BID ADDENDUM #2

Date: July 28, 2025

Project: RUHS Cardiac Catheterization Lab Suite & Hyperbaric Facility Expansion

Re: Bid Addendum #2

B4 NEW ROOF ACCESS DOOR INFILL - JAMB @ MULLION
SCALE: 6" = 1'-0"

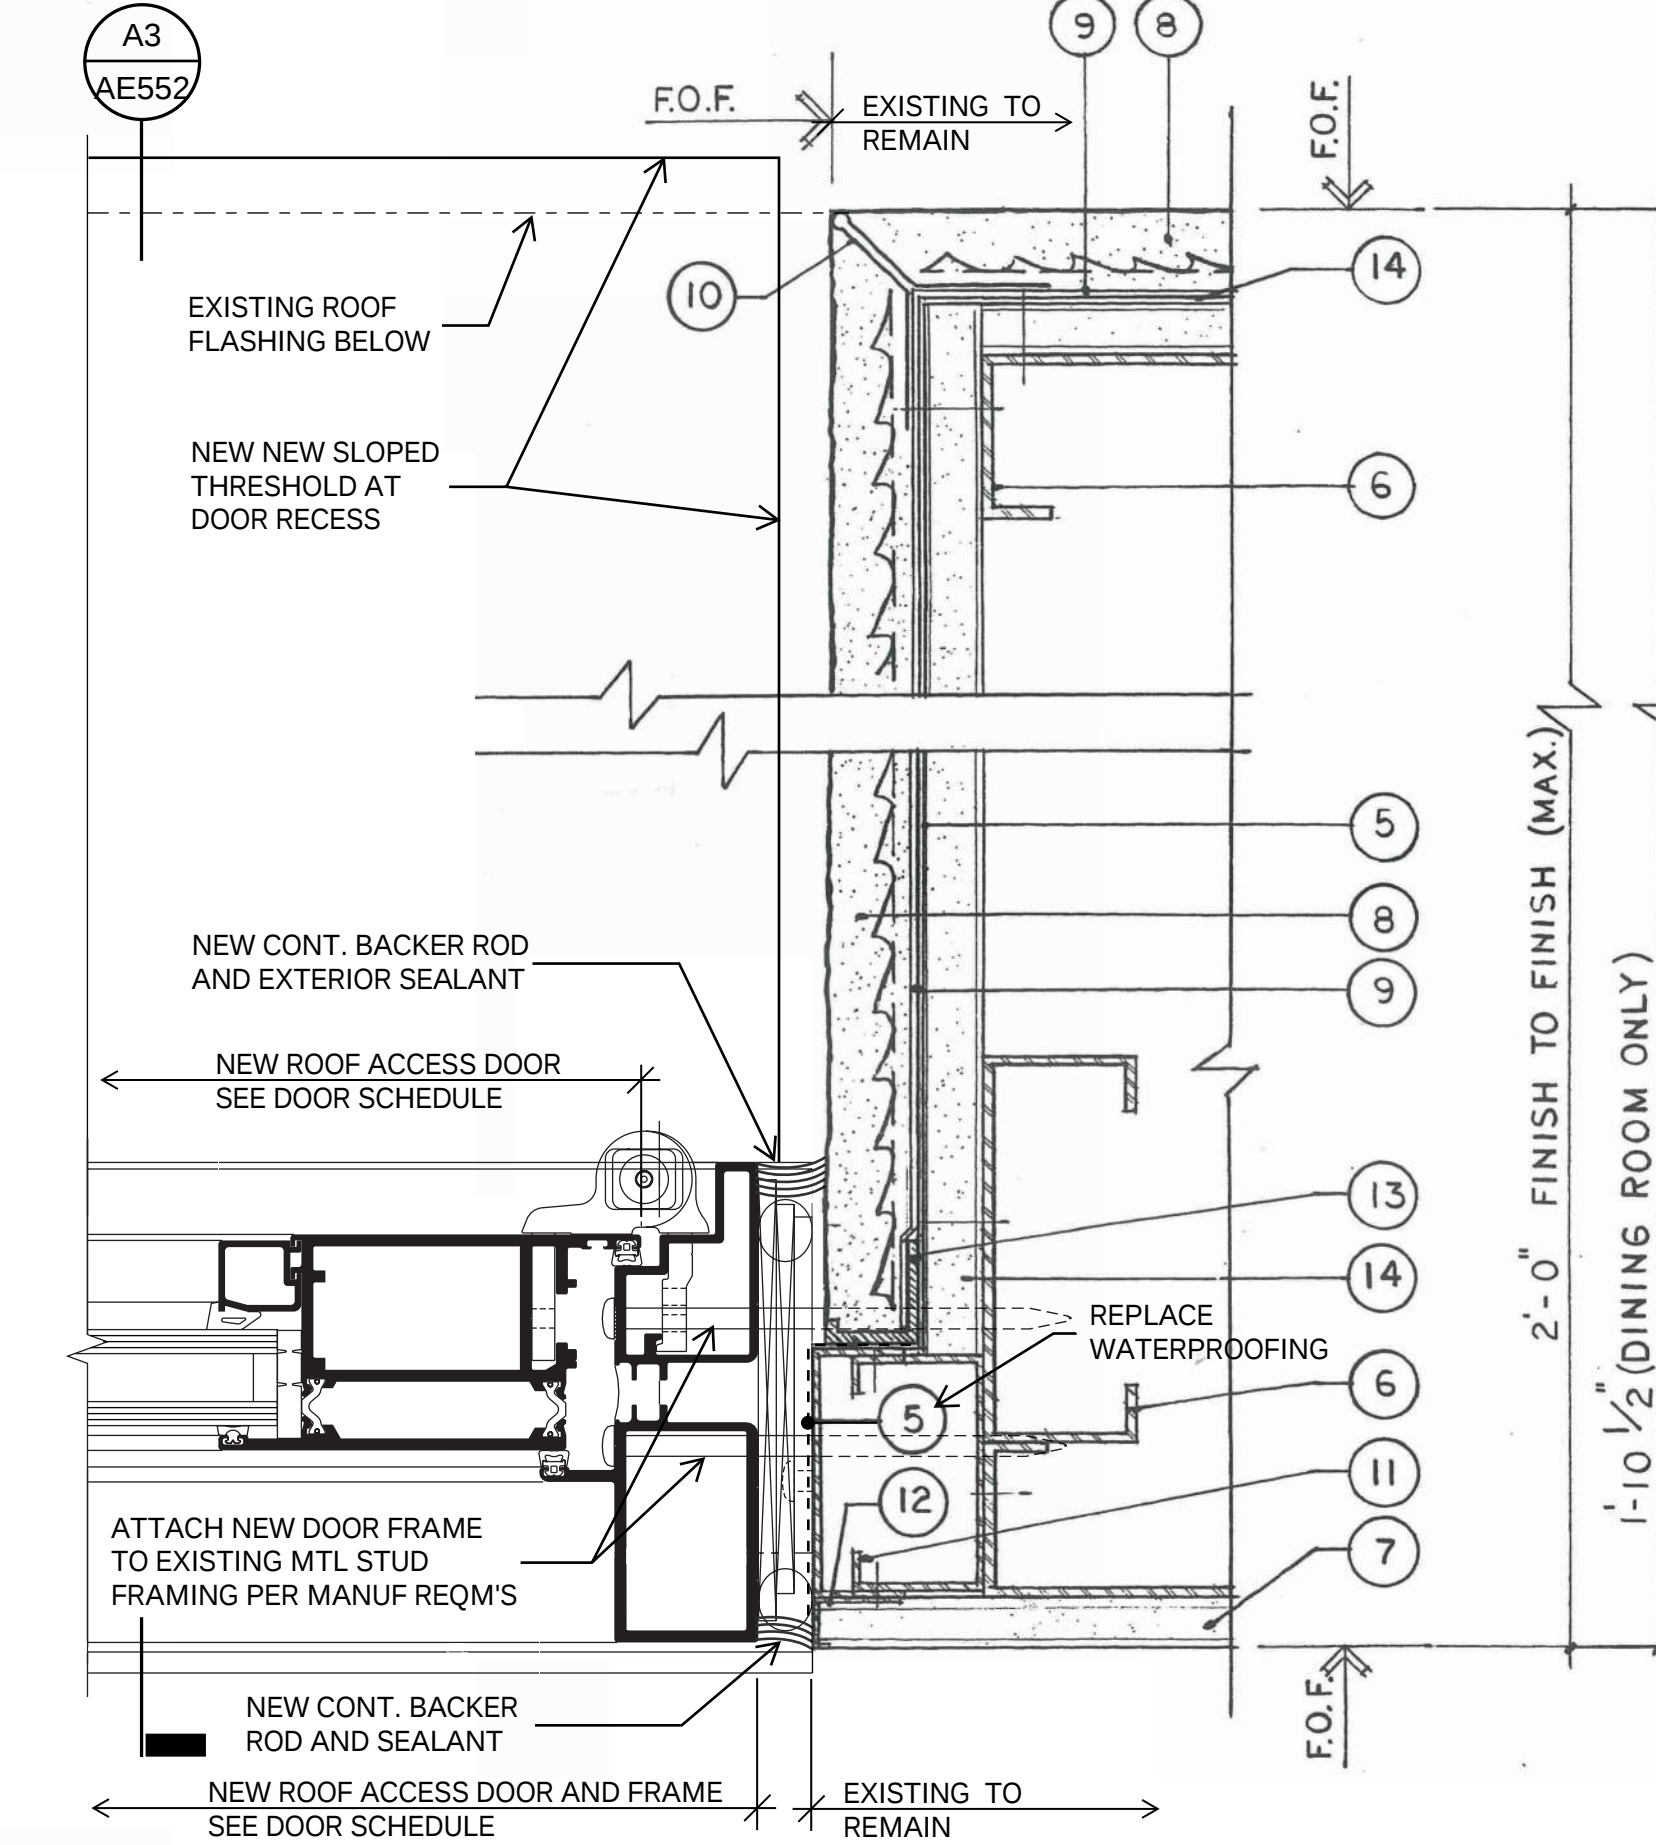
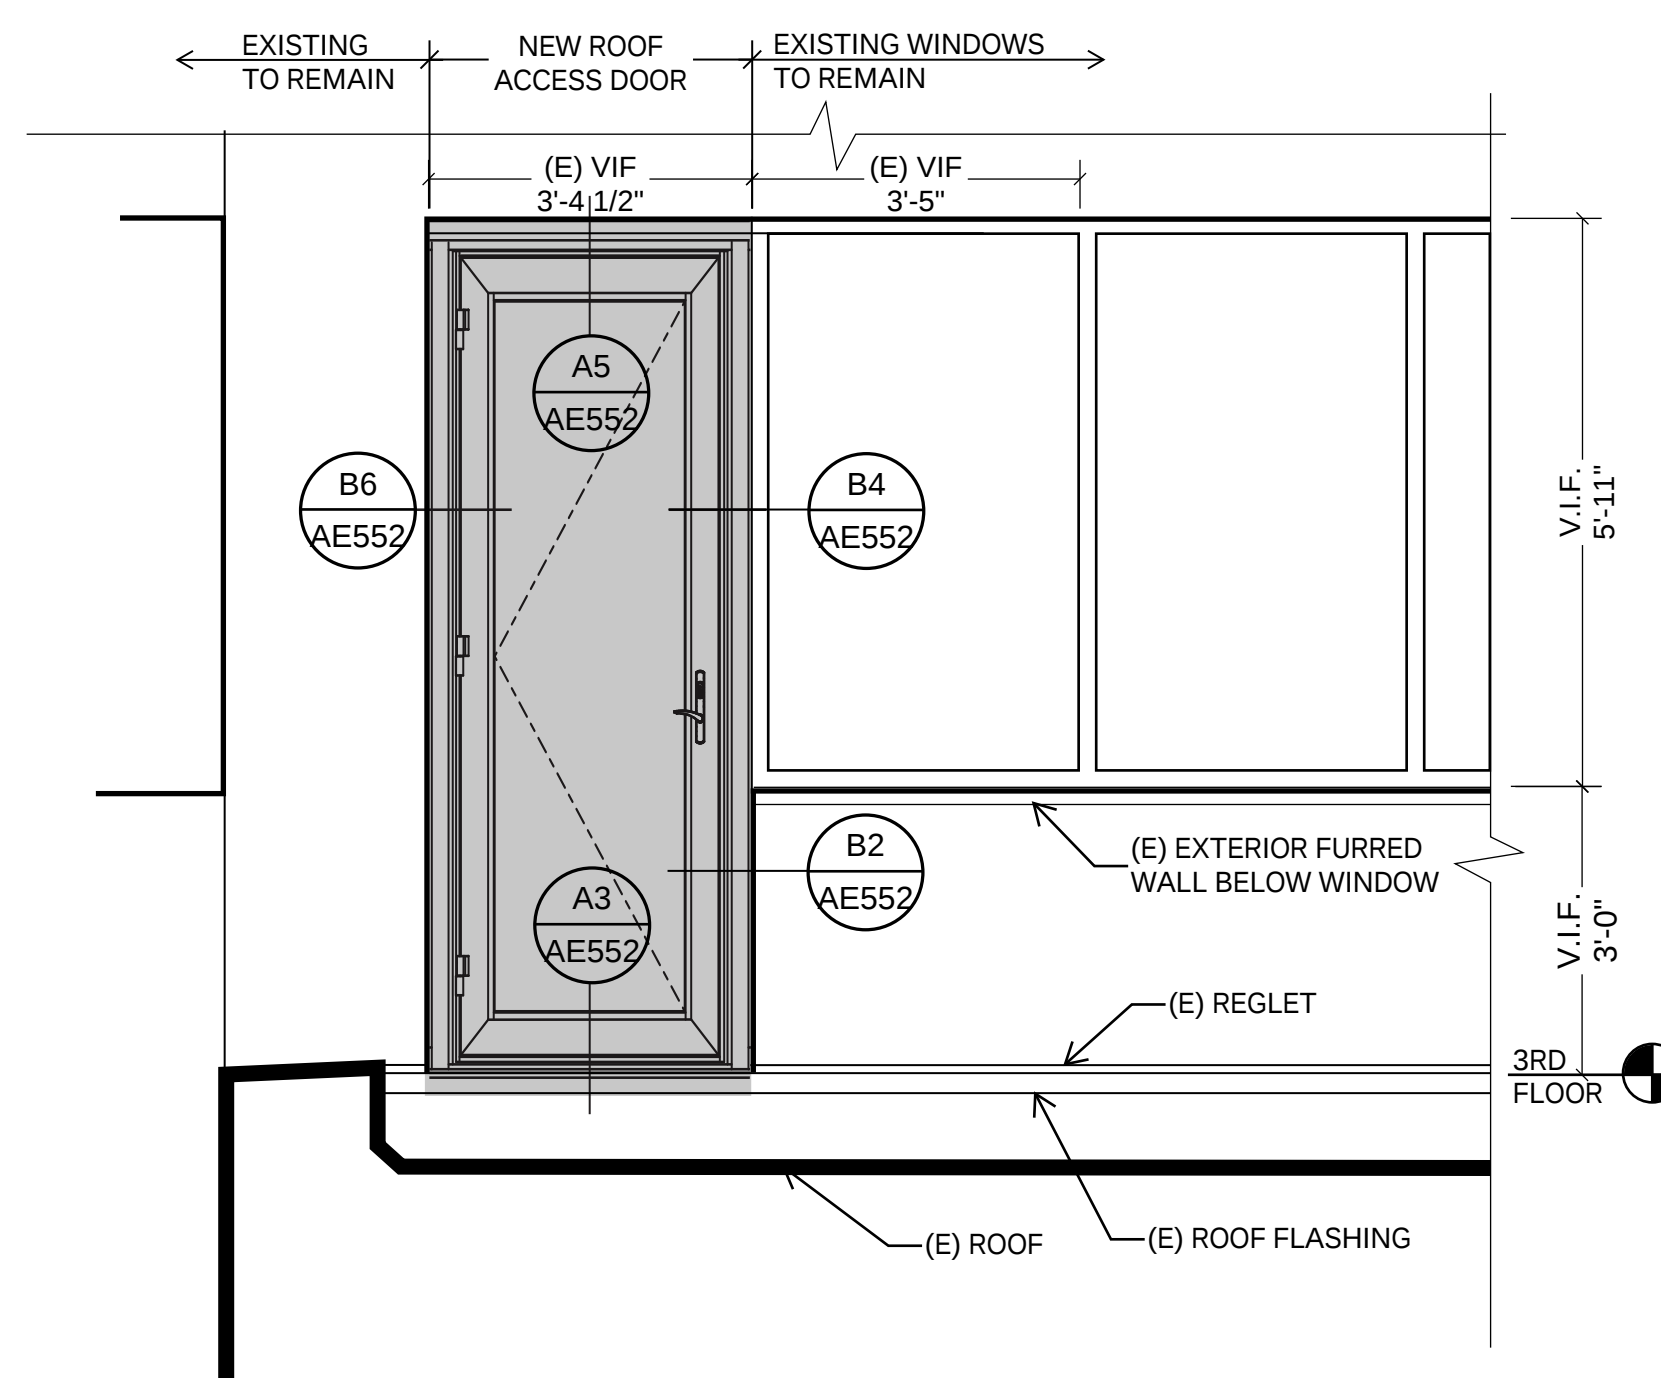
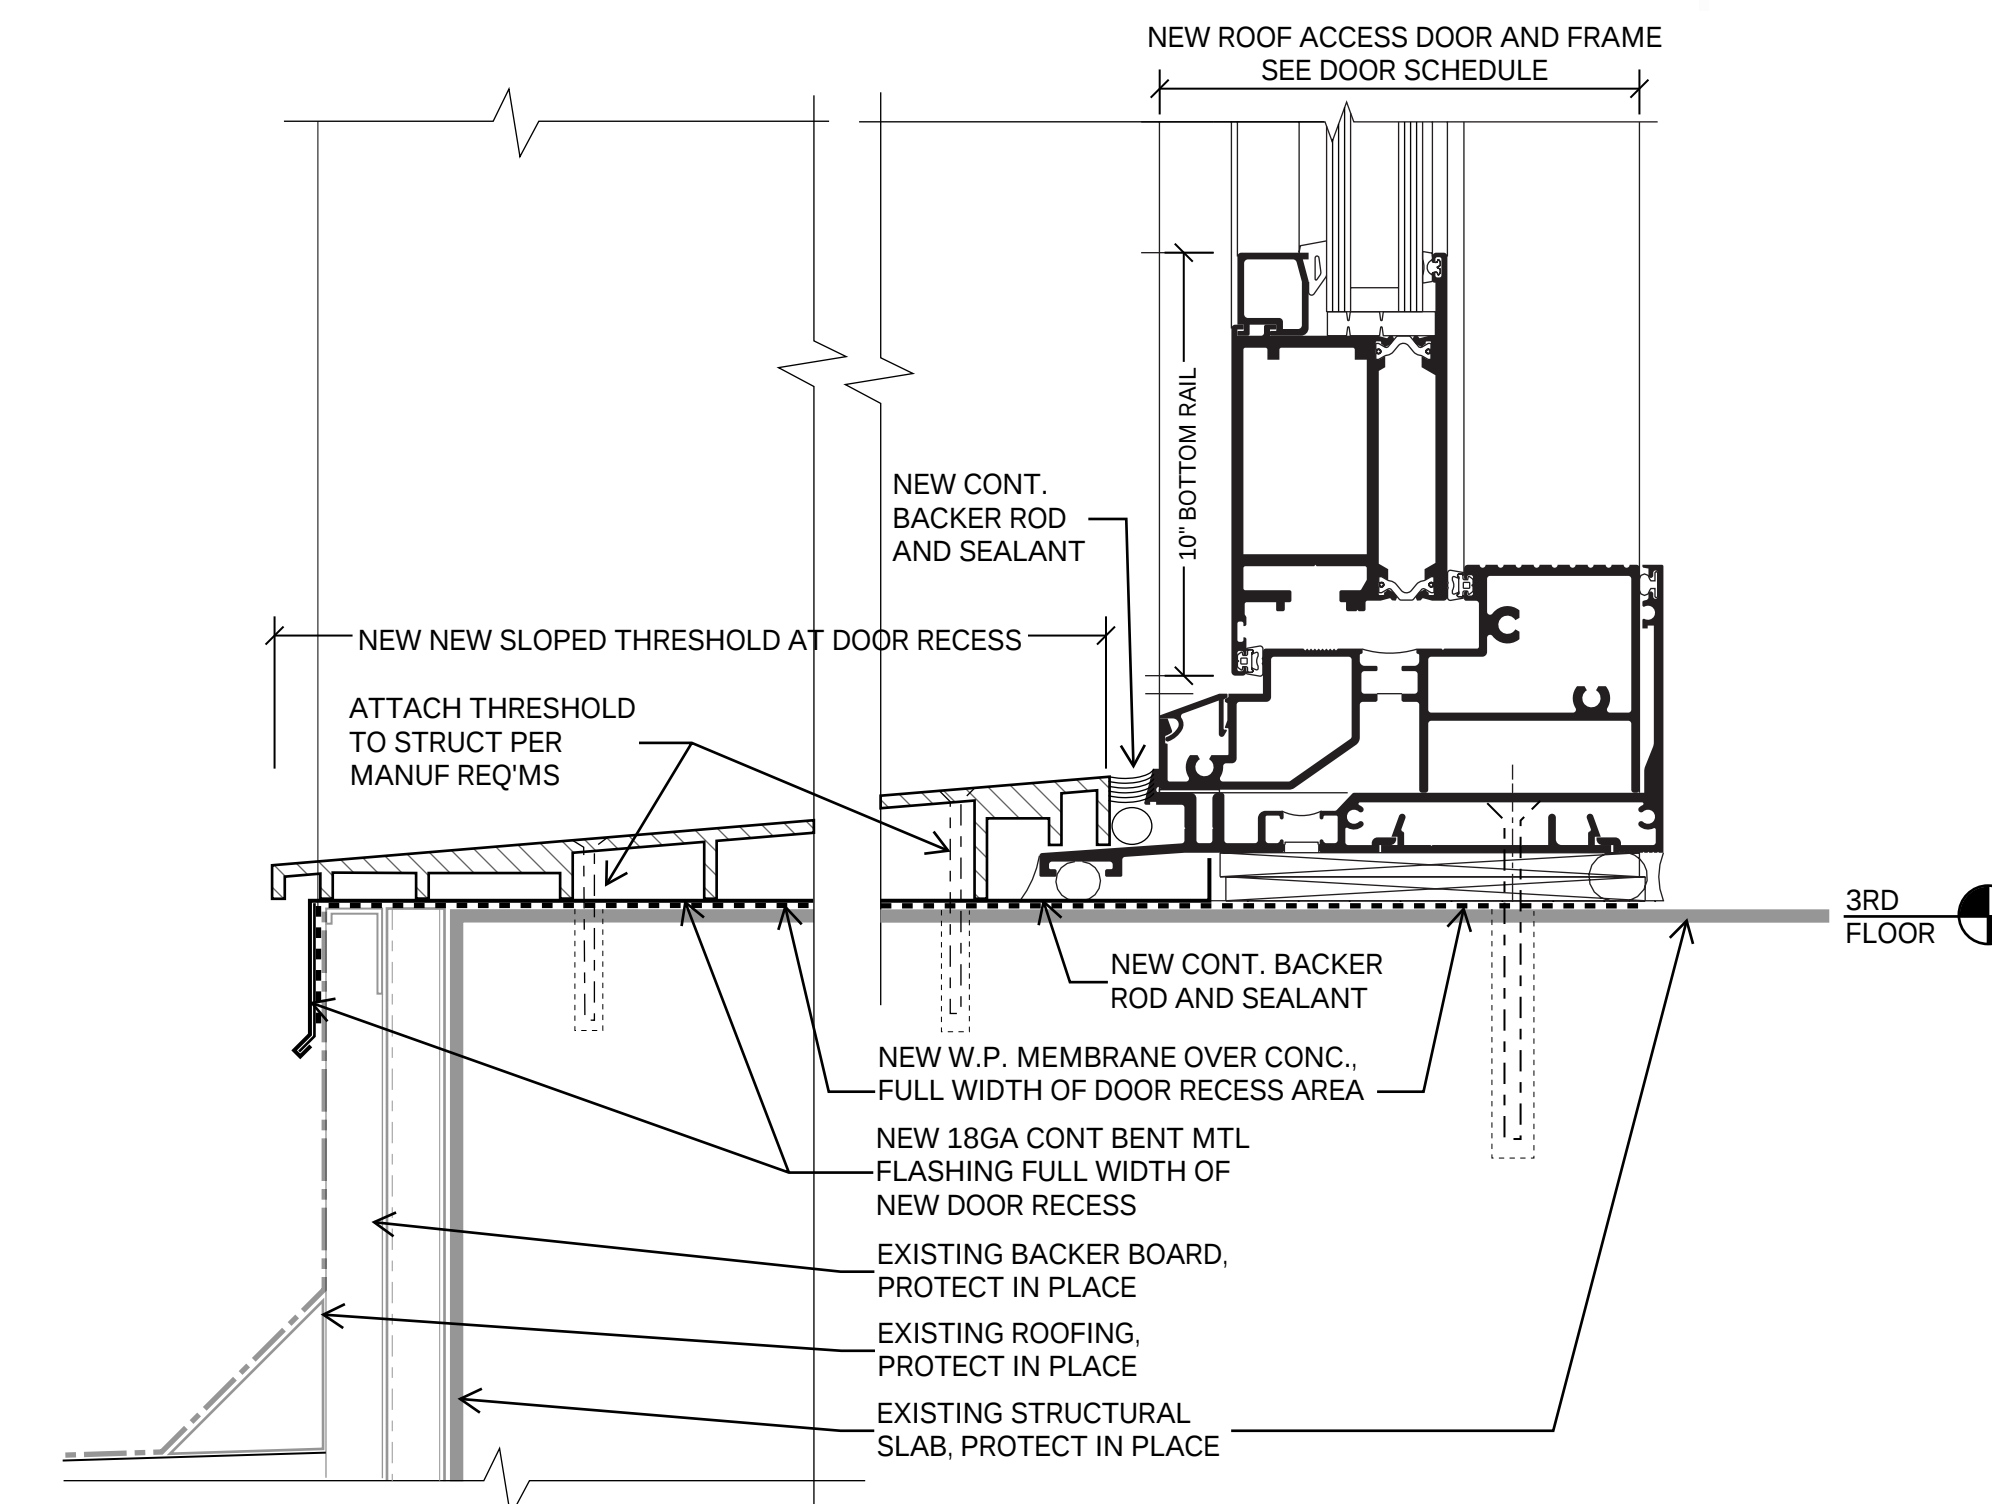
2. New demo plans and details describing the demo of an existing roof access hatch in the existing exterior storefront window and a portion of the exterior furred wall below the window.
3. New remodel plans and details describing the installation of a new roof access doorway within a single window bay of the existing exterior window system.
